UNITED STATES PATENT AND TRADEMARK OFFICE

Office Action Summary	Application No. 10/590,139	Applicant(s) DUGGAL ET AL.	
	Examiner BRUCE E. SNOW	Art Unit 3738

DETAILED ACTION

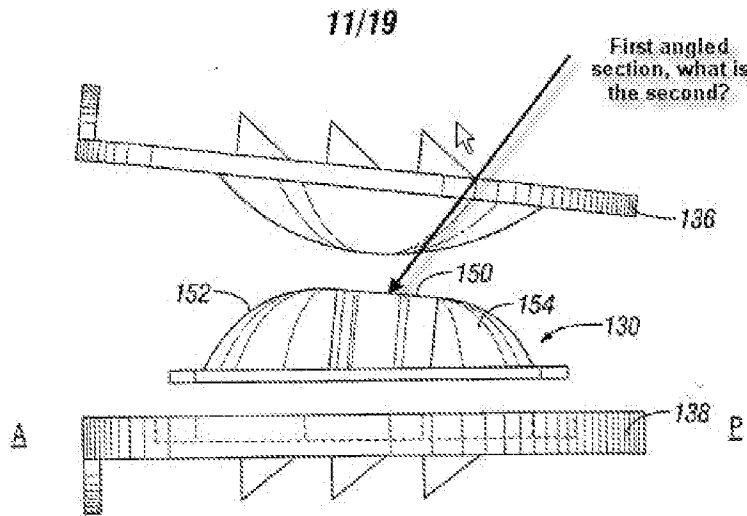
Regarding claim 32, *“first and second bearing surfaces positioned between the first and second bone engagement surface, at least one of the first and second bearing surfaces comprises an angled section”* is indefinite. It can be interpreted that bearing surface 150 comprises an angled section relative to the lower plate 138. But what is the second bearing surface which comprises an angled section? Why is it considered angled? Additionally, the claim language implies that it might be angled or might not be angled. Which is correct?

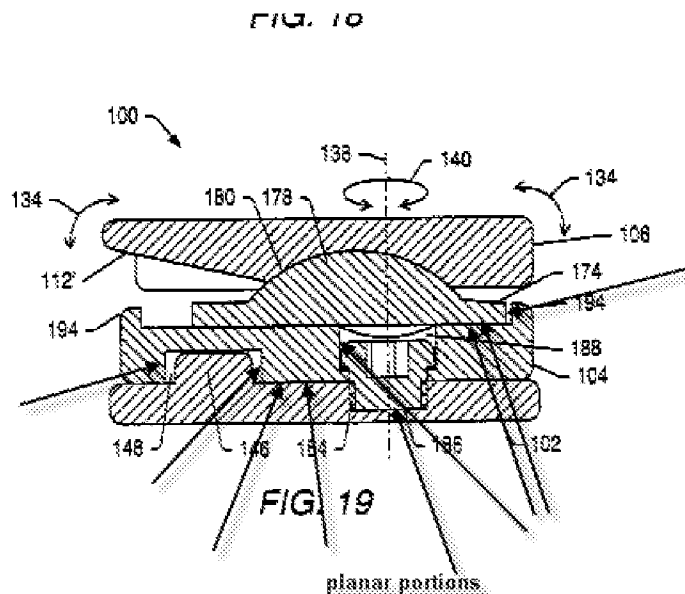
Krueger et al teaches an intervertebral disc prosthesis comprising first and second endplate members 102, 106 and a nucleus 104, 174. Said first and second endplates having first bone engagement surfaces (self-evident) and further having first and second engagement feature which can be broadly interpreted as being flat, elements 108 in figure 18, etc. The prosthesis further comprising numerous bearing surfaces including 186 (identified as 174 in the figure below) which can be interpreted as having "an angled section" having a constant slope from anterior to posterior.

As shown in the figure above, the prosthesis further comprises numerous third and fourth bearing surfaces which have planar portions. The bearing surfaces cooperated to provide a “preferred” lordotic angle.

Fig. 1

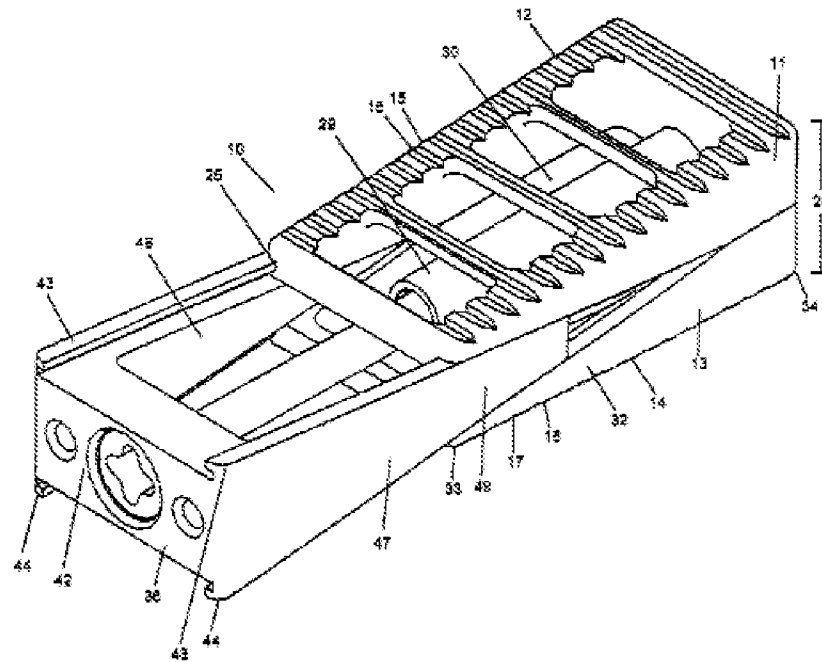
Baynham et al teaches an intervertebral disc prosthesis comprising first and second bone engagement surfaces (self-evident) and a nucleus 42 positioned therebetween. Said nucleus having a first bearing surface having a first straight portion (self-evident) opposite a planar bearing surface (self-evident) which are non-zero slope relatively oriented.
